Agenda
Village of Arlington Heights
Zoning Board of Appeals
Buechner Room, 1st floor

Arlington Heights Village Hall
33 S. Arlington Heights Road
Arlington Heights, IL 60005
January 8, 2018
7:00 PM

- A. 1176 N. Beverly Ln. - ZBA#17-059
- B. 2914 N. Mitchell Ave. - ZBA#17-060
- C. 935 N. Haddow Ave. - ZBA#17-061
- D. 1301 N. Illinois Ave. - ZBA#17-062
- E. 2101 S. Arlington Heights Rd. - ZBA#17-063

EXTERIOR
ELEVATIONS
A3

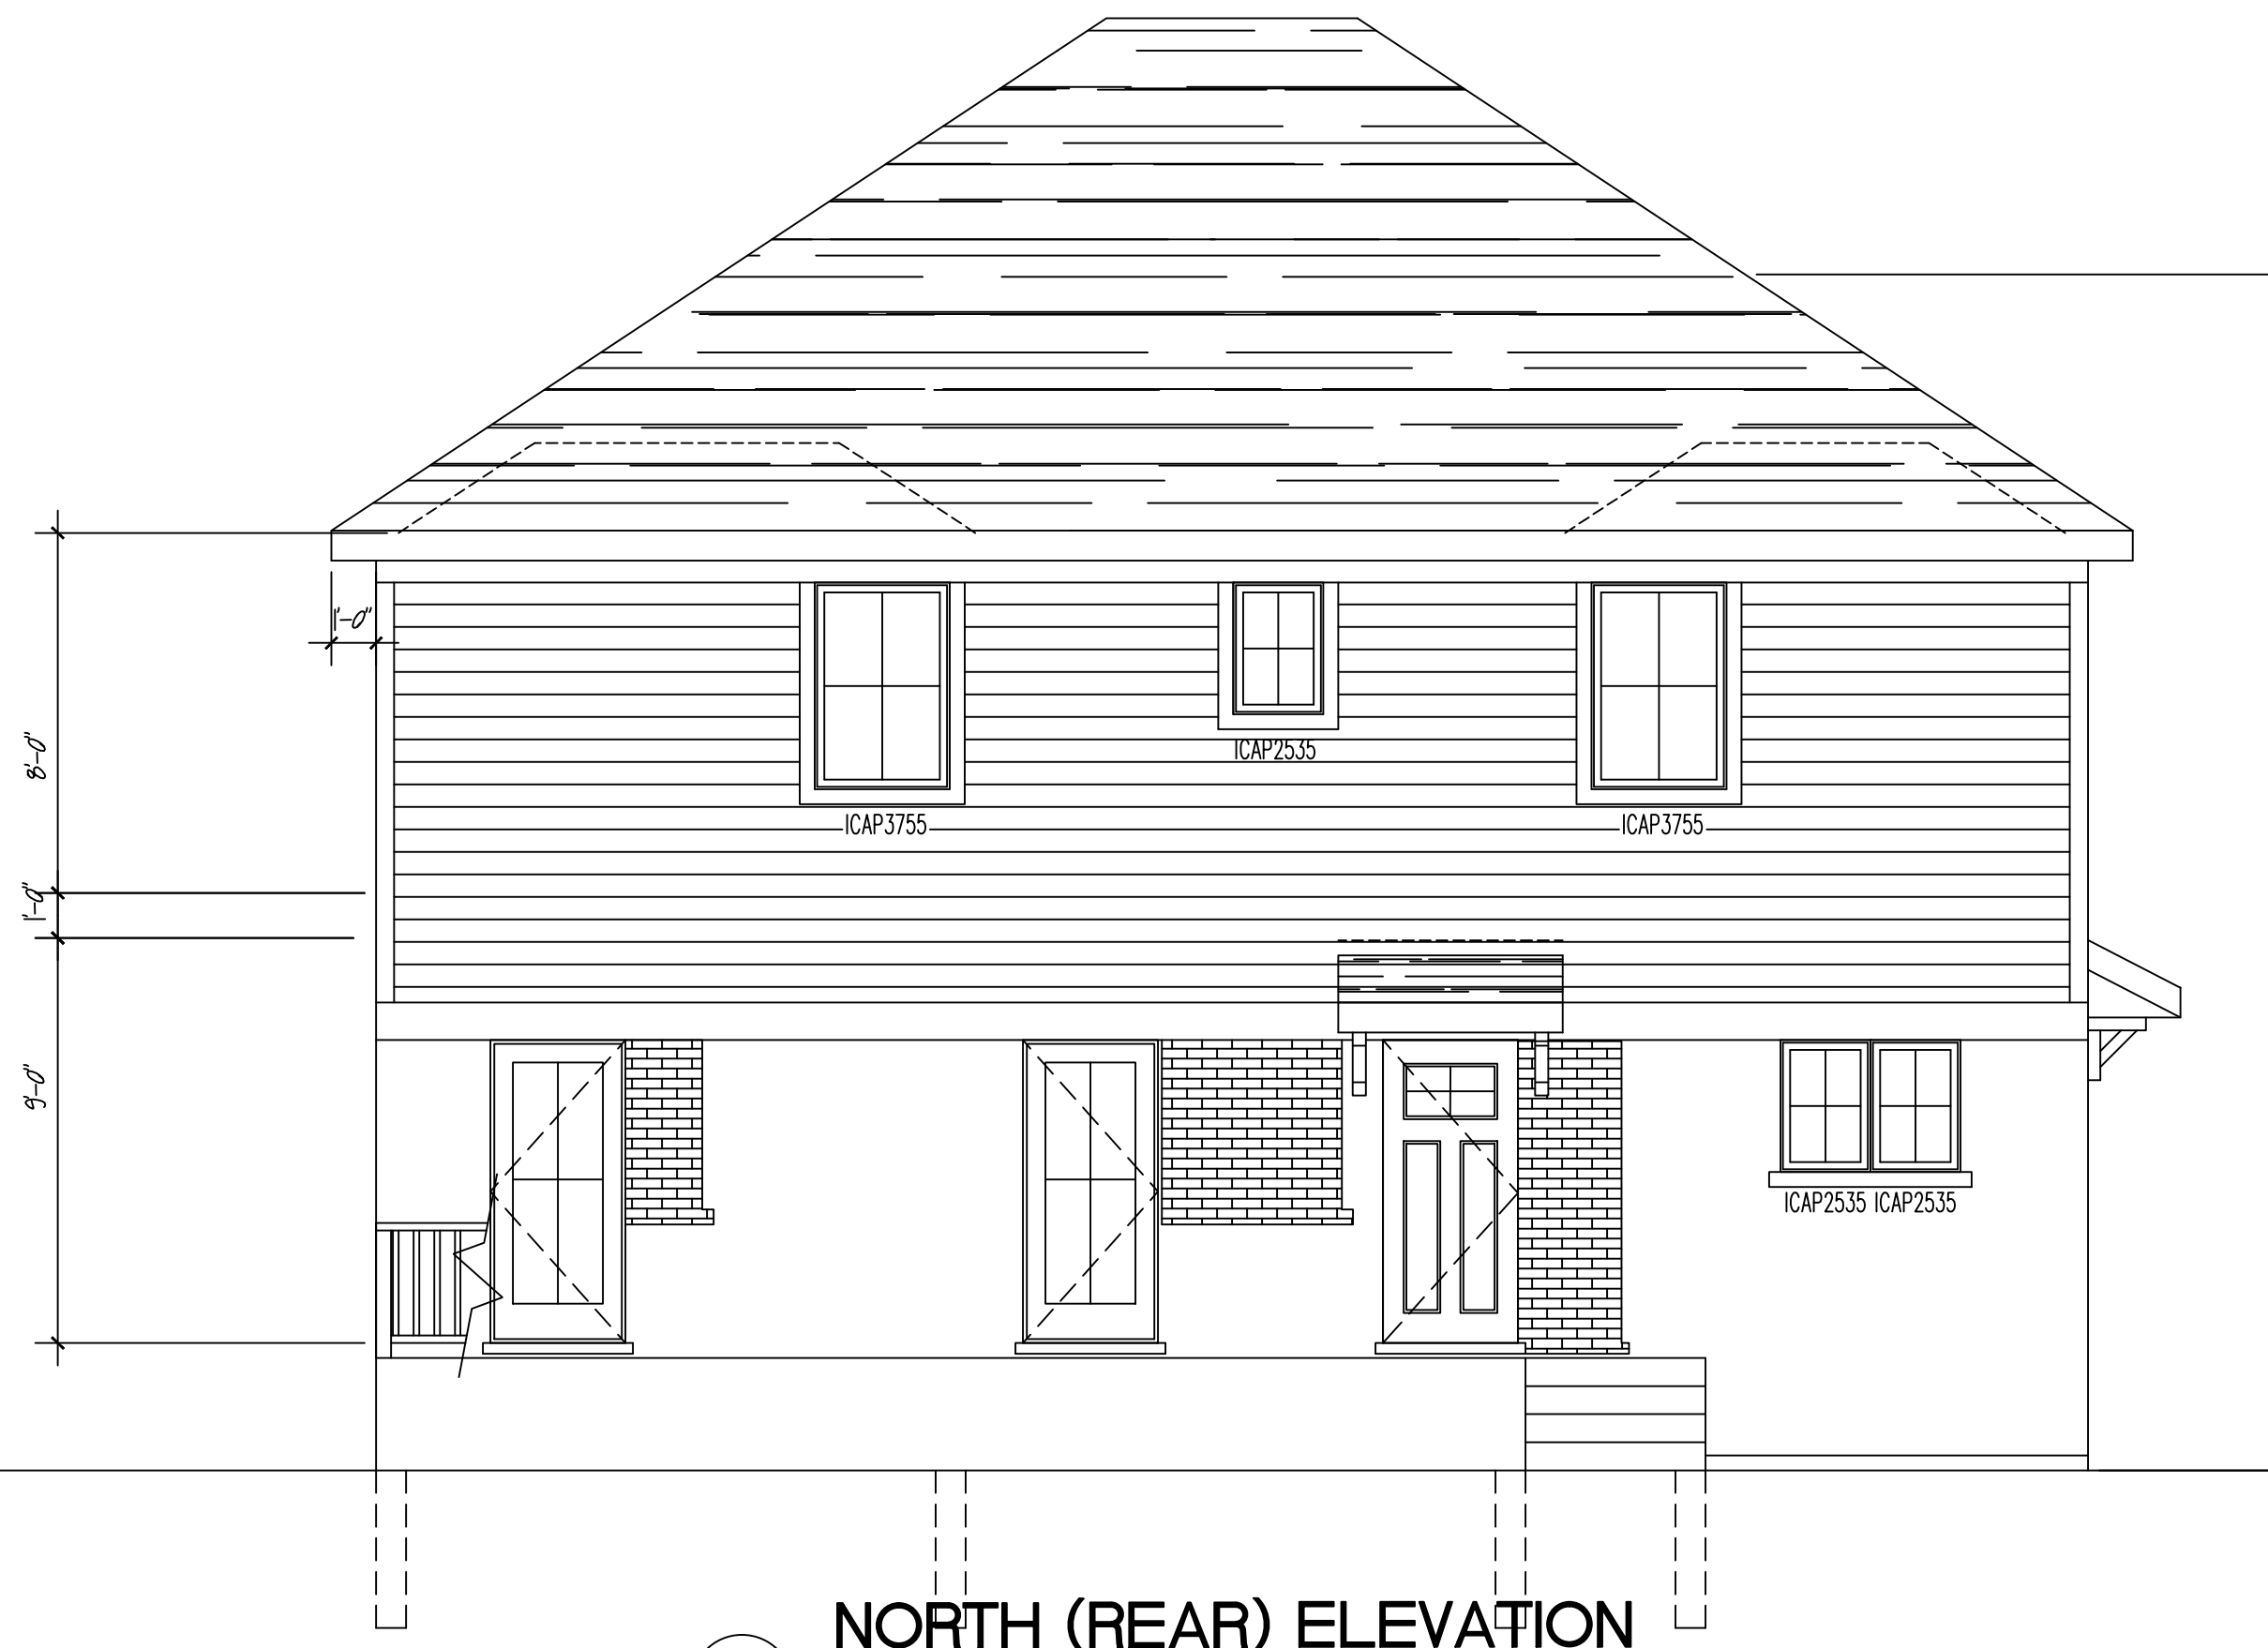
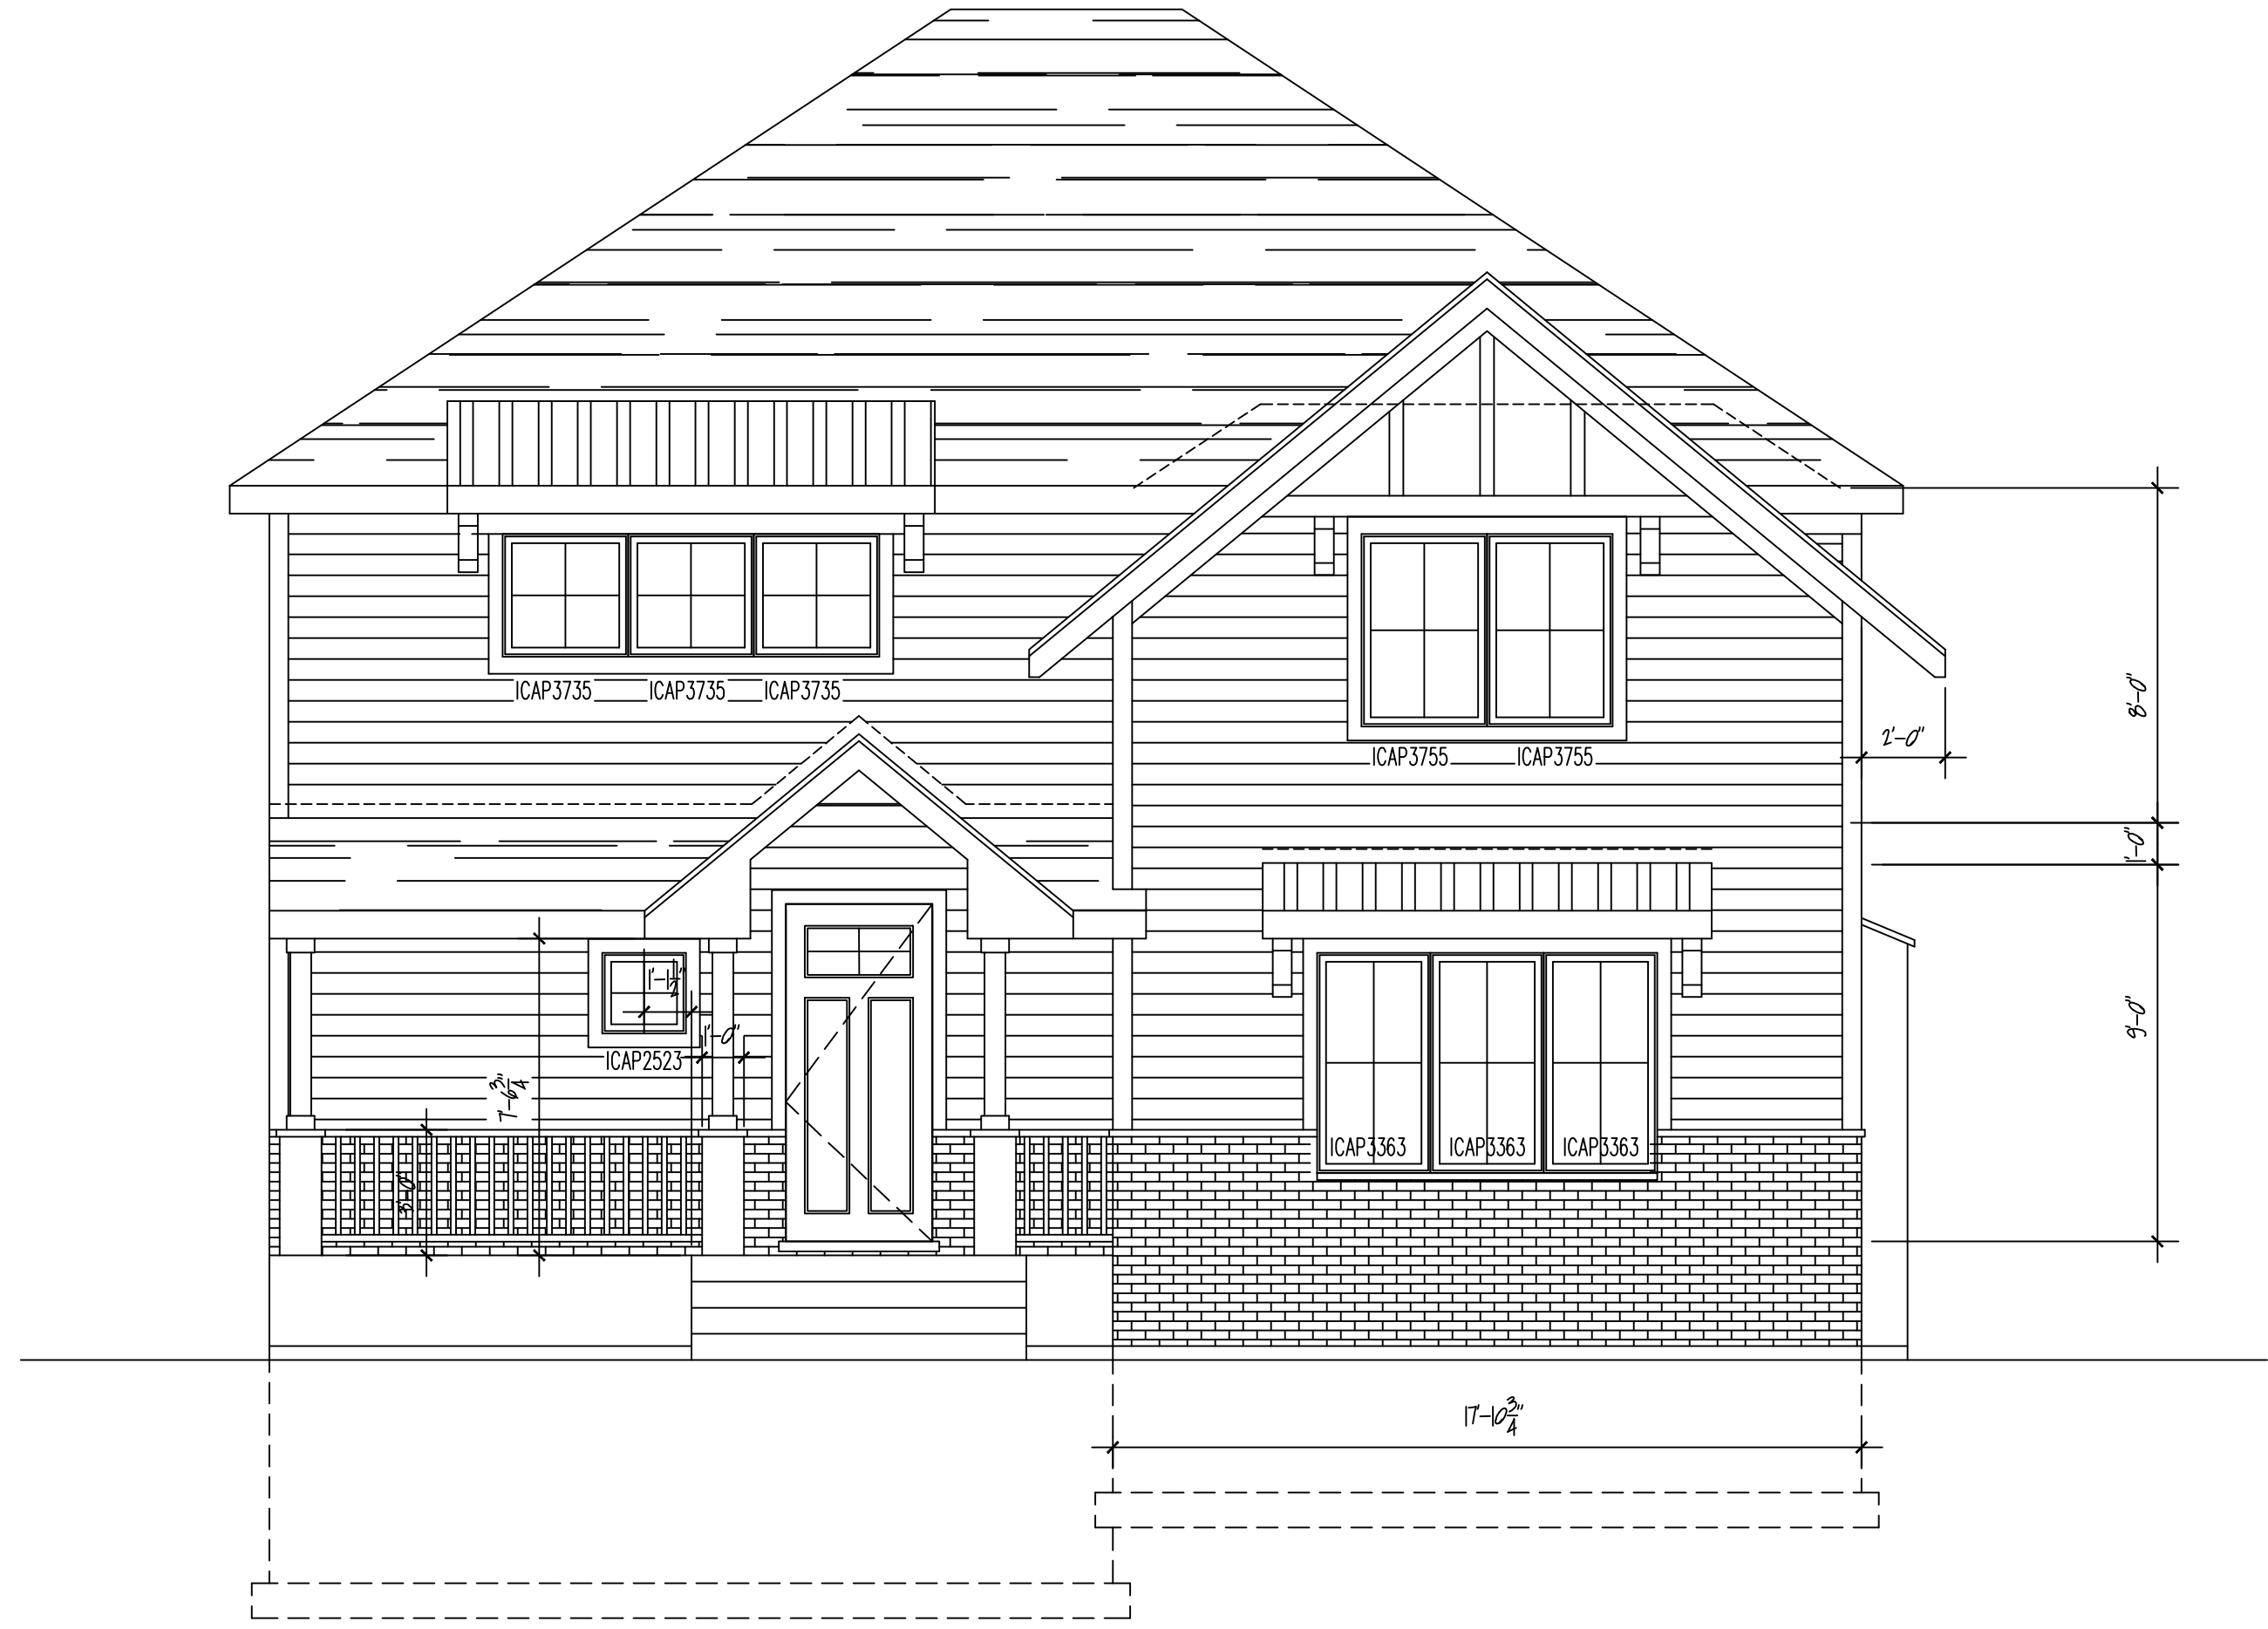
NOTE: The plans are for a second story addition/remodel and the setback is existing. The existing home also does not have any eaves on the east side.

The Engineering Department has **NO OBJECTION** to the proposed setback variance for the structure, however; due to the 2' eaves, there will need to be gutters to prevent excess storm water runoff from negatively impacting the neighbor's driveway/property. The Engineering Department has **NO COMMENT** on the building height.
